Product Change Notification

PCN-ICC-3153-2019

Business Unit	Product Line Code	Type of Change	Action	Date of Issue
ICC - Industrial Cabinet	BE2	Product Change Notification	Notify Distributors and Field	1/31/2019

Description for Product Change Notification

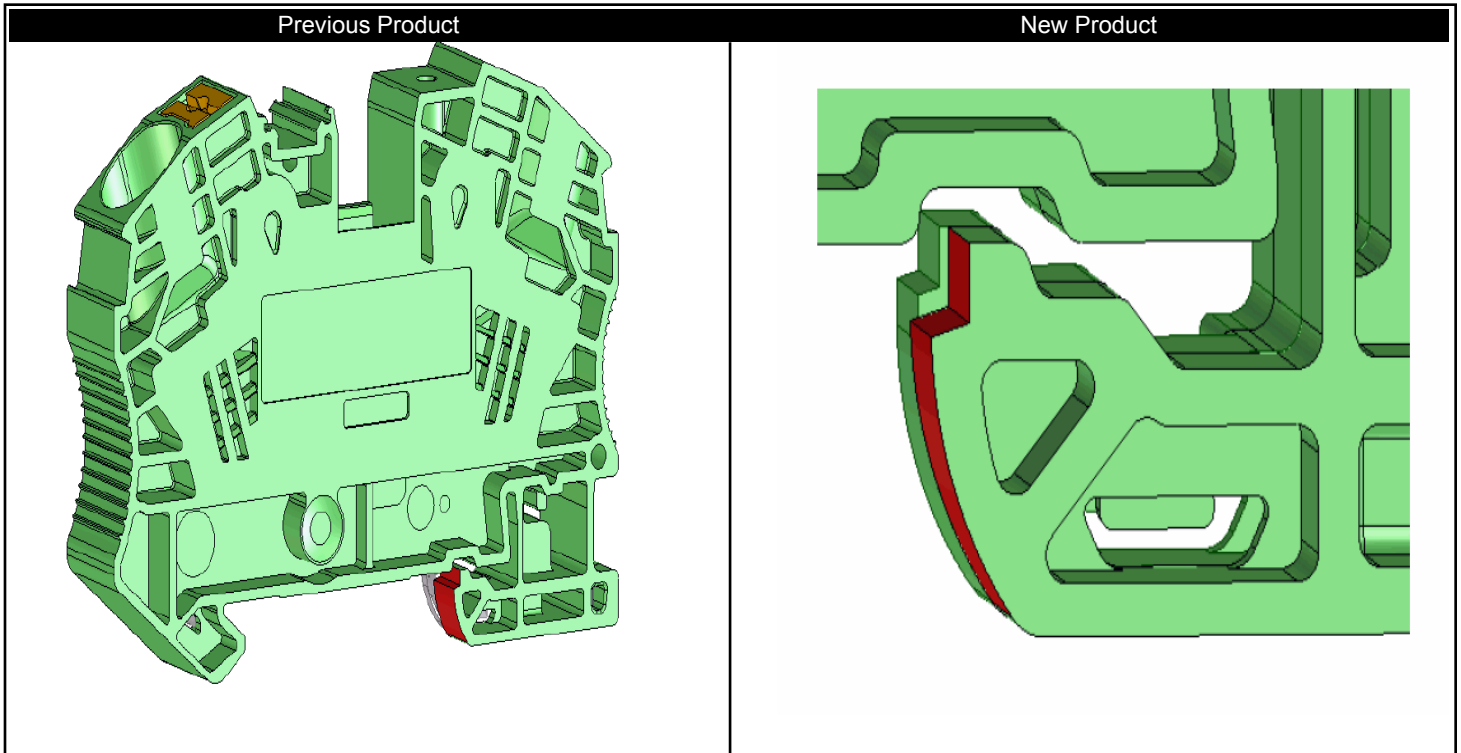
There will be a small modification of the snap lock design at the PE ground foot area. Due to a slight contour adjustment of the PT 16 N-PE, the locking behavior on 35 mm DIN rail is optimized.
